Service Bulletin

Bulletin No.: 21-NA-149

Subject: Engine Wire Harness Chafing / IPC Gauges Sweep / IPC Warning Message / SES/Check Engine/MIL / No Start / No Crank / Runs Rough / Stalls / Reduced Engine Power / Various DTCs

This bulletin replaces PIT5677E, PIT5713A, PIT5751C and PIT5742. Please discard PIT5677E, PIT5713A, PIT5751C and PIT5742.

5394681

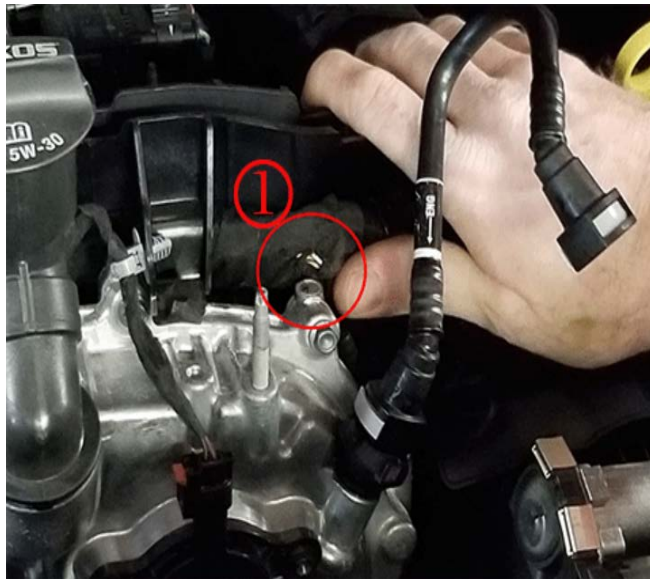
This Cause pertains to vehicles equipped with engine 2.7L, L3B only.
These concerns may be caused by engine harness contact with under hood components.
Caution: This Document Only Applies To VINs NOT Covered by Customer Satisfaction Program N192219370 Please Verify In VIS Before Proceeding
Shown below are areas that should be inspected for this concern.
Inspect the engine harness as it crosses over top of the Camshaft Carrier Cover.
Harness damage can occur at any point across the Camshaft Carrier Cover.
Typical inspection locations shown below.

5324748

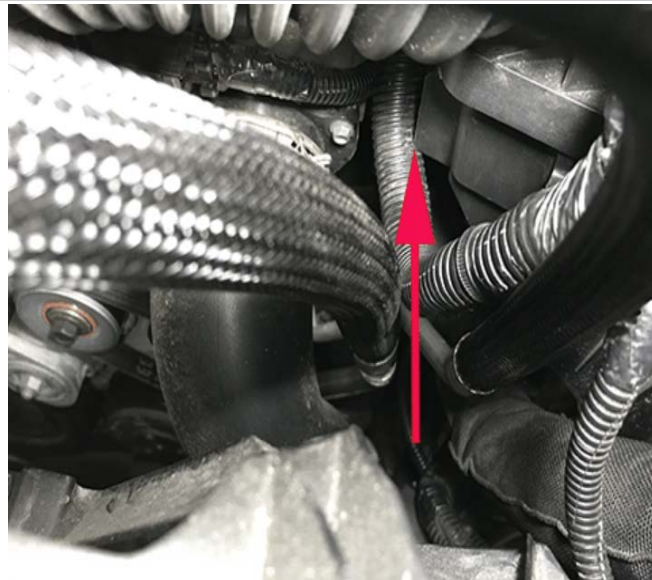
Example of engine wiring harness damage at Camshaft Carrier Cover shown below.

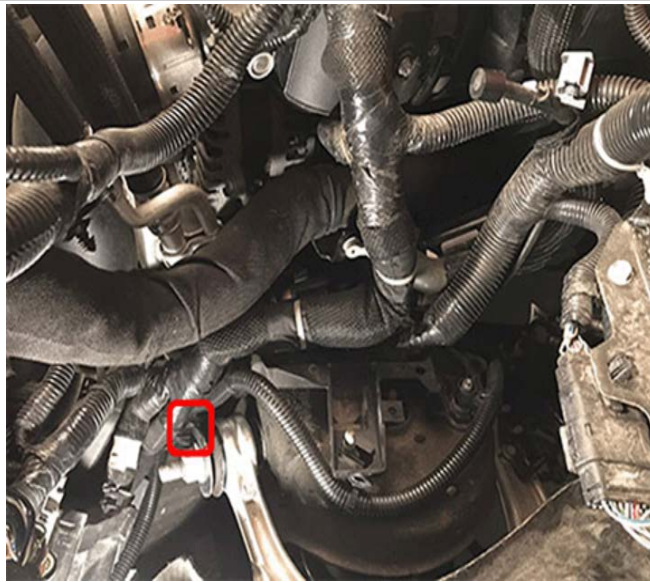
Example of engine harness damage, Lower Air Cleaner Housing removed shown below. Inspect the engine harness at the Generator Bracket and Left Front Coil Spring stud as shown below.

Note: Under normal driving conditions, the engine will rock back and forth in its mounts.

This may result in harness contact with this bracket that may not be present during engine off inspections.

5394677

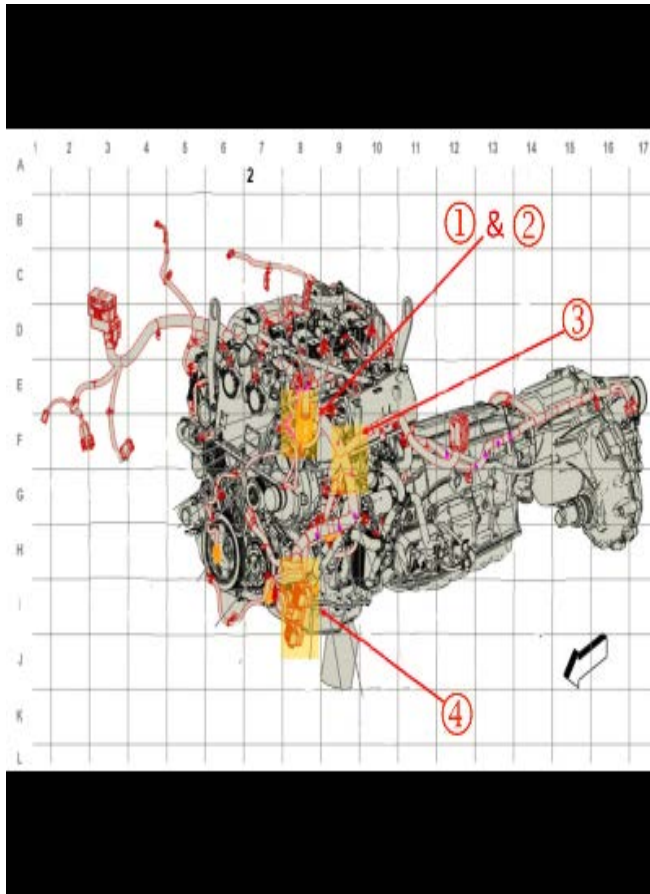
Inspect the engine harness at the Left Front Upper Control Arm Bushing as shown below.

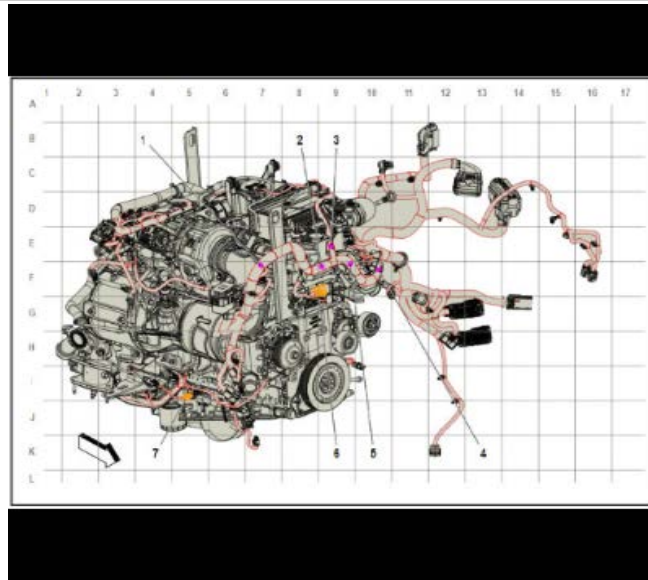
These concerns could be caused by engine wiring harness chafe on underhood components at various locations:

- Front corner of the left hand cylinder head (1)
- Drive belt idler pulley bracket (2)
- Oil Dipstick bracket (3)
- ECM/TCM bracket (4)

5949730

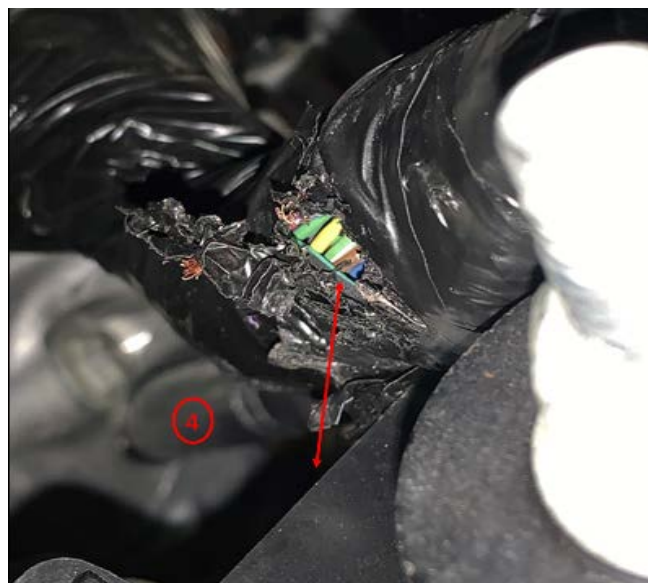
1. Inspect for poor terminal tension at connector X160, shown above, as callout 6. While inspecting X160 make sure the terminal locking feature (4) is not missing.
2. Inspect the fuel injector connectors to make sure they are fully connected/seated.
3. Inspect the fuel injector wiring harness near the X160 connector (3) for being pinched/shorted/chaffed, as shown below (5).

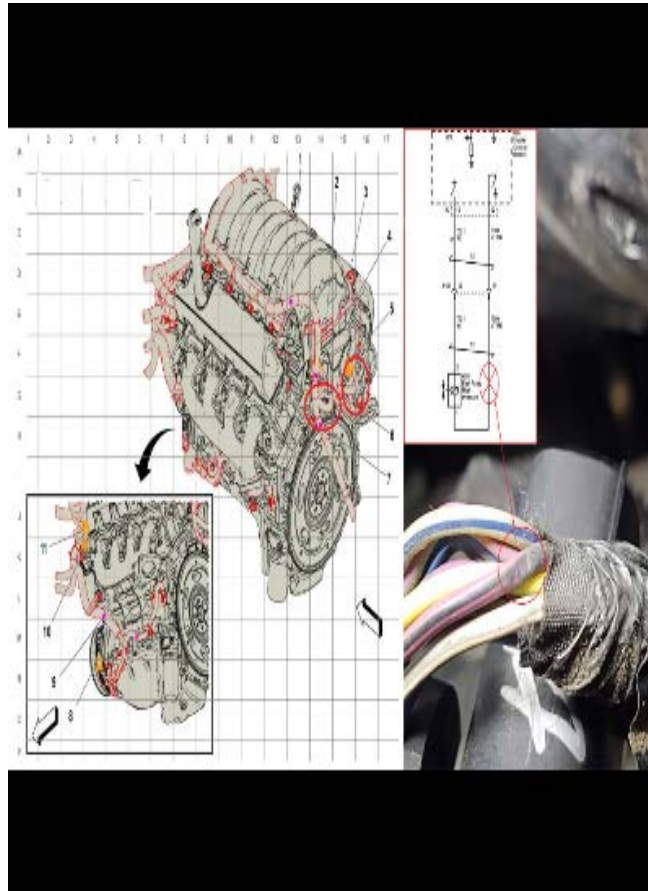
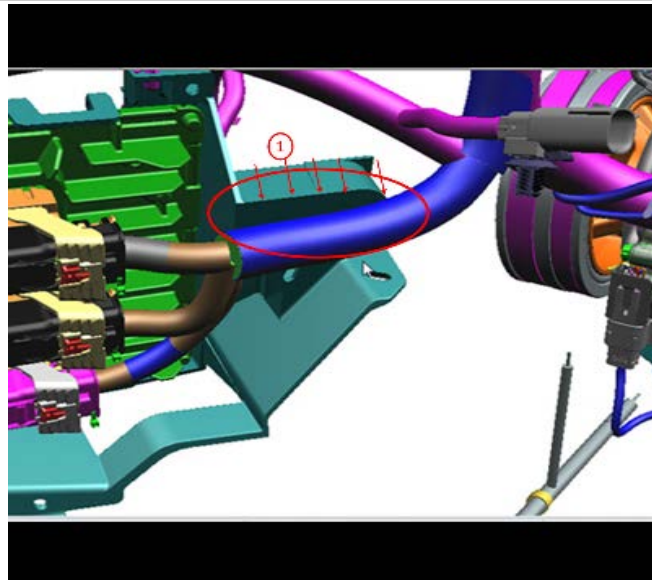
Examples of extreme wire chaffing.

An example of firewall insulator chaffing

Other areas of concern.

The cause of the condition may be an engine wire harness clip was removed during production due to ergonomic issues (hand clearance and branch stiffness). This led to an uncontrolled branch that came into contact with a sharp edge (1) & (2) on the ECM/TCM bracket, driver side upper control arm, and/or shock tower and caused chaffing during engine vibration and roll.

5810432

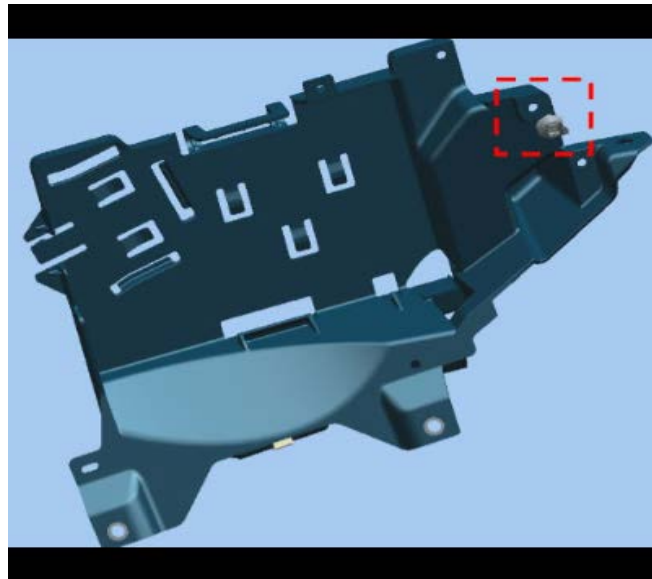
Insert the Zip Tie style Fir Tree Clip into the location shown below in the ECM Mounting Bracket.

5810431

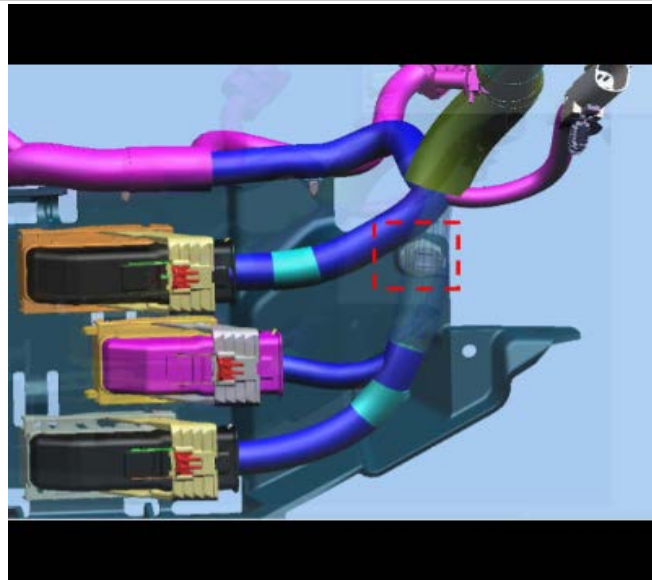
Zip Tie Fir Tree Clip installed securing the harness as show below.

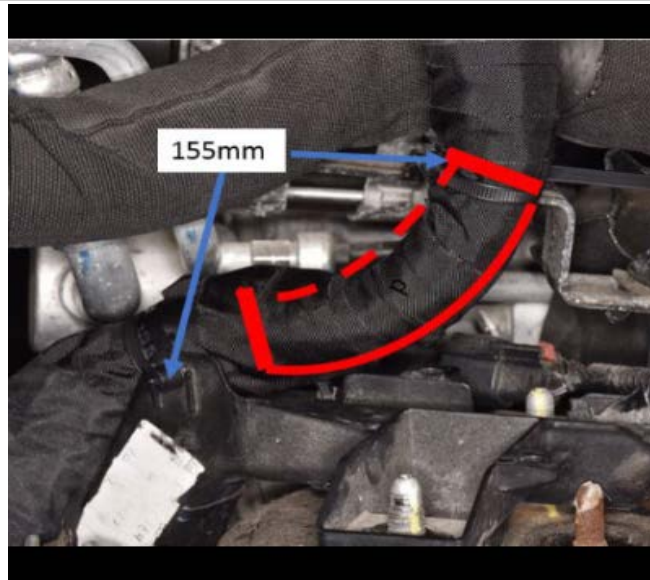
Measure up 155 mm from the Zip Tie style Fir Tree Clip located on the plastic Channel. Install the Kevlar Velcro Sleeve PN 84820678 155 mm up the engine wiring harness as shown below to ensure that the sleeve extends 25mm above the Zip Tie style Fir Tree Clip located at the Generator Bracket as shown below.

5810434

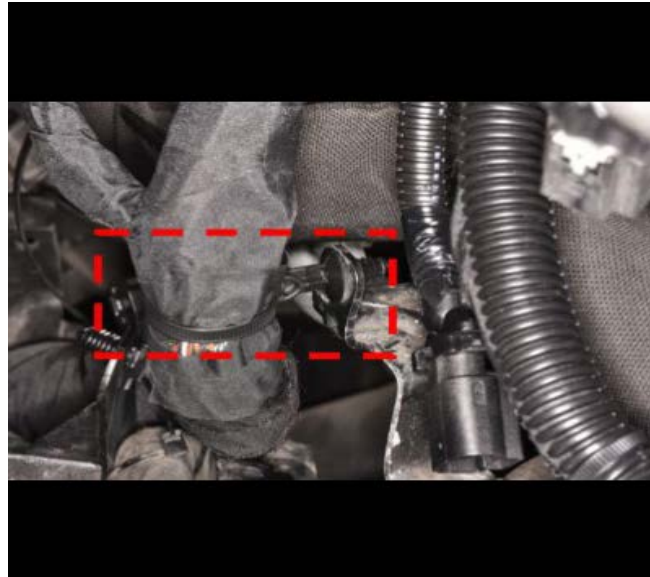
Install the updated Zip Tie style Fir Tree Clip GM PN 13596790 in the Generator Bracket as shown below.

5868341

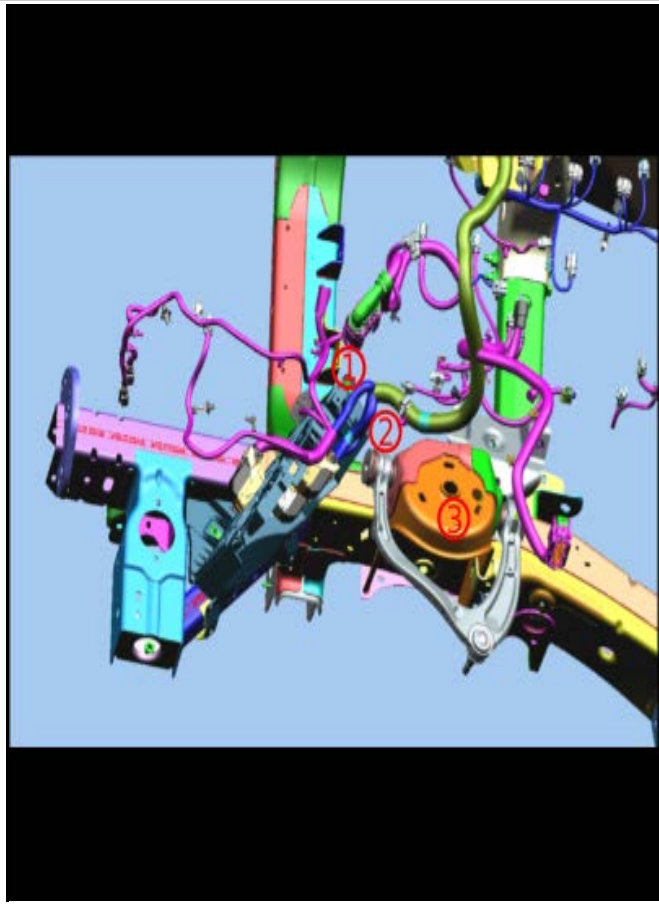
3. Locate the three contact points where the wire harness is chaffing, the ECM/TCM black bracket (1), the upper control arm (2), and the shock tower bolt (3).

5868350

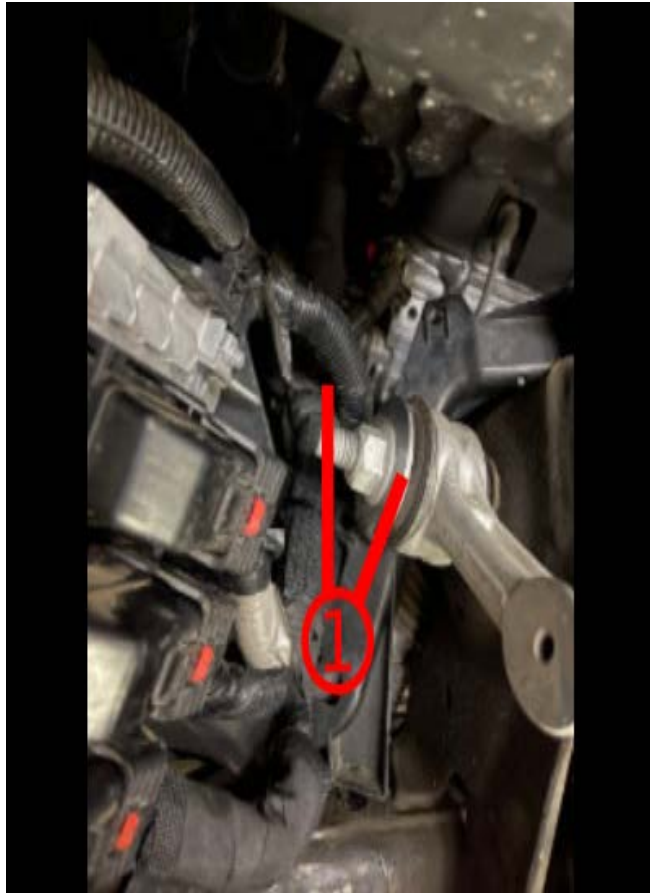
5. Wrap the wire harness with the shorter Engine Harness Sleeve then utilizing zip ties and two small holes in the bracket (1).

5868357

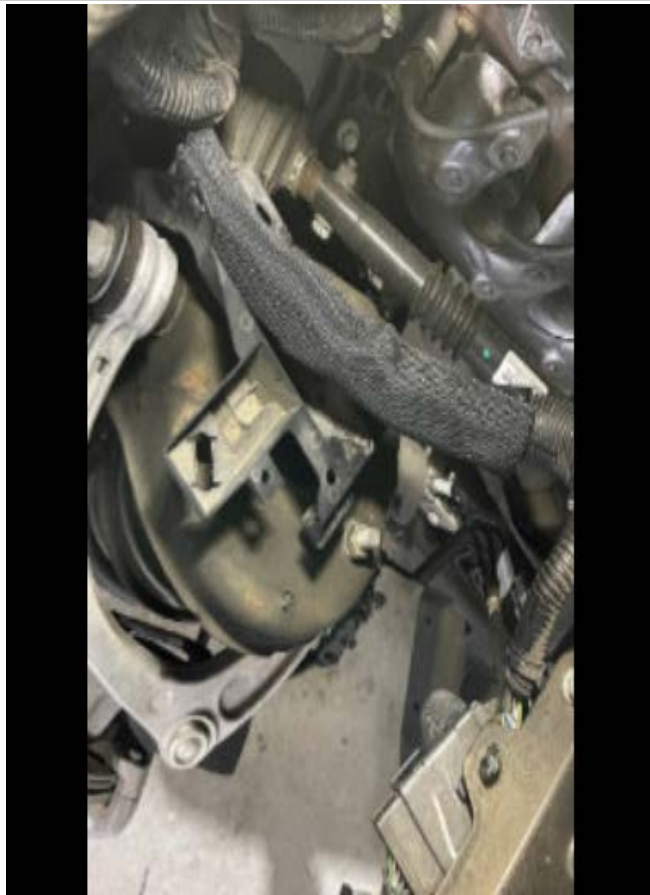
8. Wrap the harness in the shorter Engine Harness Sleeve then wrap with anti-abrasion tape secure it to the harness clip above the ECM/TCM bracket (1) to keep out of the way of the upper control arm.

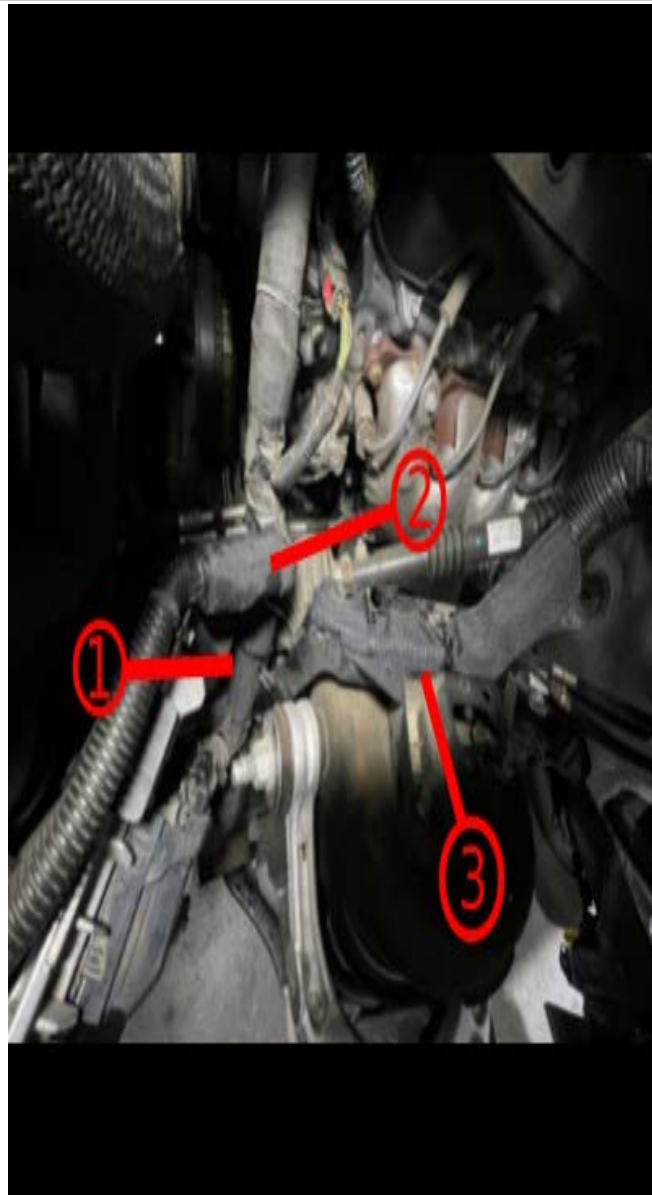
10. Using the long Engine Harness Sleeve, wrap the harness and secure it snug to the canal using zip-ties.

11. Verify the wire harness is wrapped and secured at all three points, the ECM/TCM Bracket (1), Upper Control Arm (2), and the Shock Tower (3). Then reassemble the vehicle.
12. Reinstall the front wheelhouse liner and tire and wheel. Refer to *Front Wheelhouse Liner Replacement* and *Tire and Wheel Removal and Installation* in SI.
13. Remove the support and lower the vehicle.
